***INDEPENDENT EXPERT GROUP
REVIEW OF THE TULLAMARINE LANDFILL
MANAGEMENT AND CAP DESIGN***

Melbourne, VIC, Australia

March 2011

Figure 3.1 Recommended cover cross section for a hazardous waste or low level radioactive waste landfill (NRC, 2007)

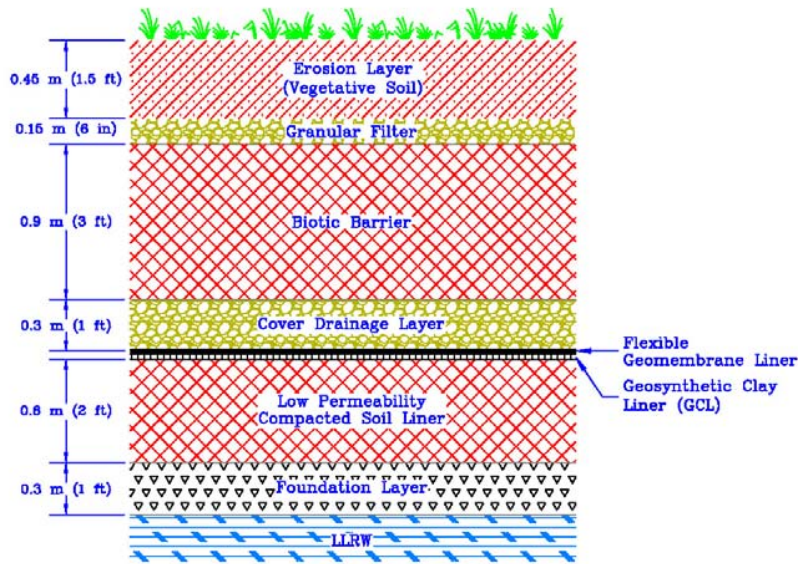
Comparison of the Tullamarine cap design and construction with the best practice standards described above shows both substantial compliance with best practice standards as well as some deviation from these standards. In general, the cap cross section at Tullamarine complies with the standard cross section shown in Figure 3.1. Exceptions of the cap at Tullamarine from the cross section shown in Figure 3.1 include:

- placement of a blanket gas collection layer under only a portion of the cap (rather than under the entire cap); and
- omission of a biotic barrier above the geomembrane barrier layer.

In addition to the exceptions noted above, the saturated hydraulic conductivity of the drainage layer in the standard cross section shown in Figure 3.1 is from two to three orders of magnitude greater than the design value for the cap on Mounds 1 and 2 and the as-built value for the cap on Mound 3.

Figure 4.1 – Average head predictions

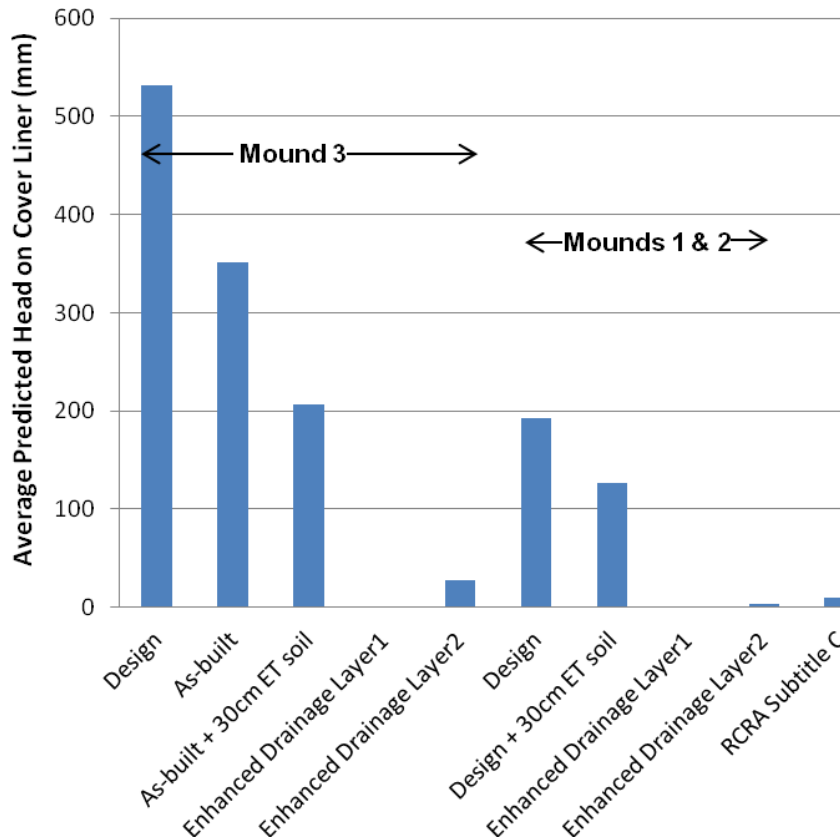
Figure 4.1 shows the difference among the various cover configurations evaluated in the infiltration analyses with respect to the average annual head in the drainage layer. Infiltration through the cap and into the waste may be assumed to be proportional to the average head in the drainage layer.

Figure 3 – Average Head Predictions

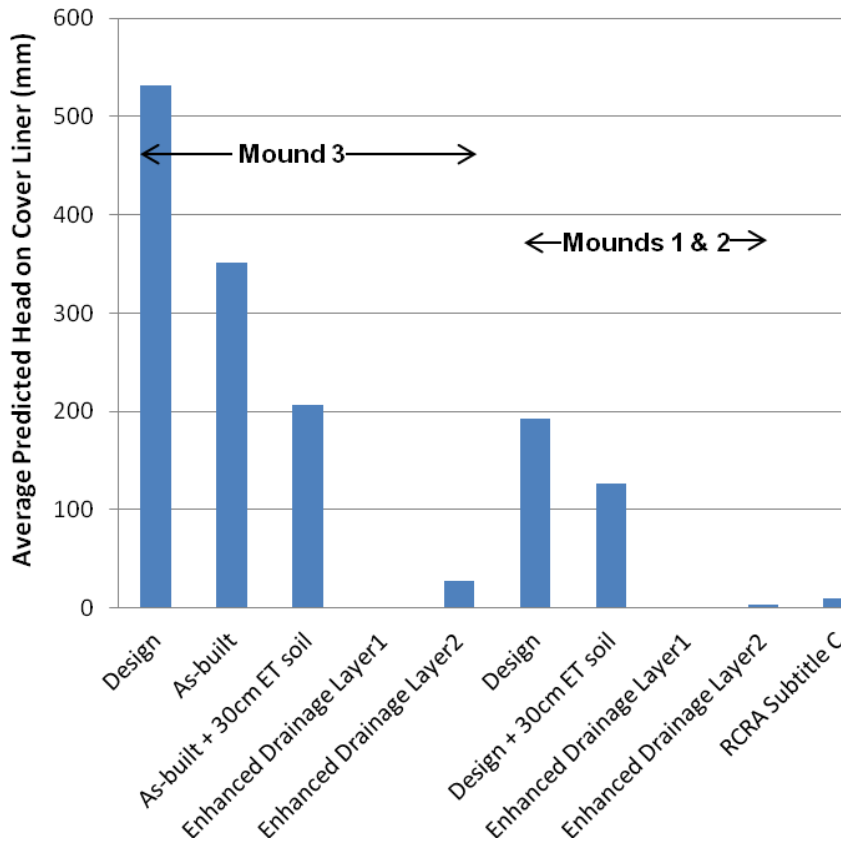
The average annual head showed a strong dependence on the properties of the drainage layer. The thickness of the evapotranspirative cover soil layer also had an impact on average annual head values. Figure 3 shows the average annual head calculated for the various cover configurations considered in the water balance analyses.
